High voltage safety

Sweden, 2018/09

Key Points:

Low Energy Necessity in Use

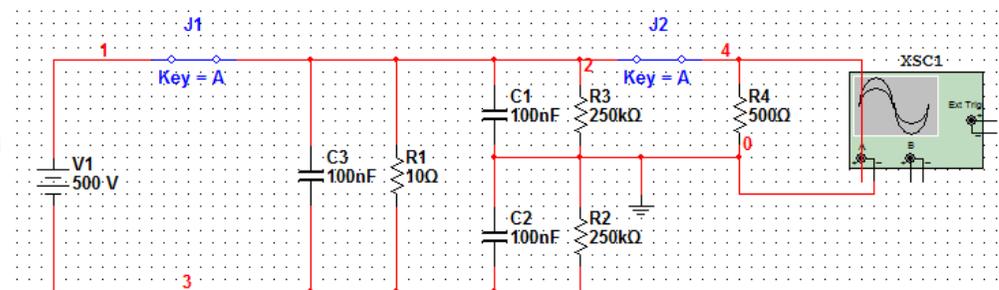
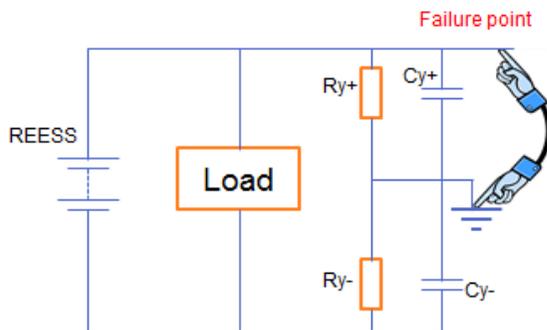
Now low energy requirement is optional choice of post crash in 5.2.2.2.

- ◆ Low energy should be necessary requirement in-use for indirect contact protection as isolation resistance requirement.

- IPXXD/IPXXB requirement when connectors are connected is necessary protection from direct contact on live part;

The simulation of touching the failure point

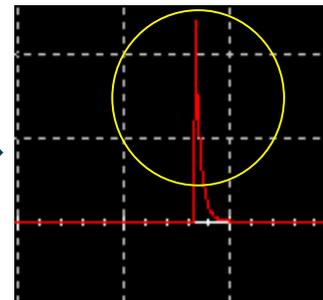
- If the energy is higher than 0.2J above 60VDC /30VAC, it's a danger to the person when there's an one point failure.

Isolation resistance measurement

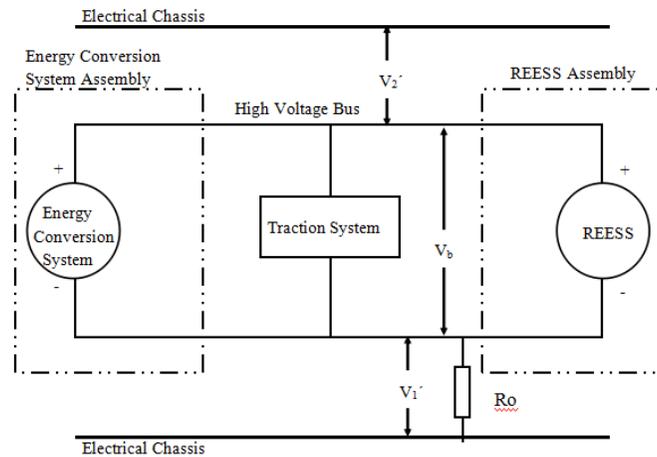
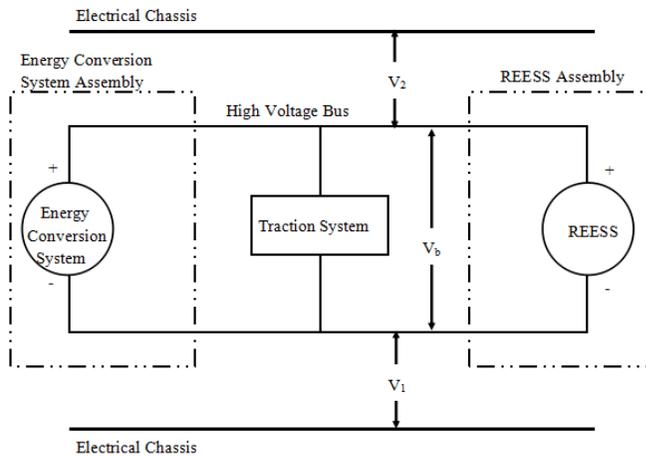
1st: Run the circuit , V_b is higher than nominal voltage;

2nd: measure V_1 ;

3rd: measure V_2 ;

measure V_1 and V_2 using two same voltmeter

4th: if V_1 is higher than V_2 , add R_0 as picture shows; (suggest $V_0=1M\Omega$)

5th: measure V_1'

6th: measure V_2'

measure V_1' and V_2' using two same voltmeter

- Voltage measured is more stable;
- This method minimized the effect of the internal resistance of the voltmeter on the result;
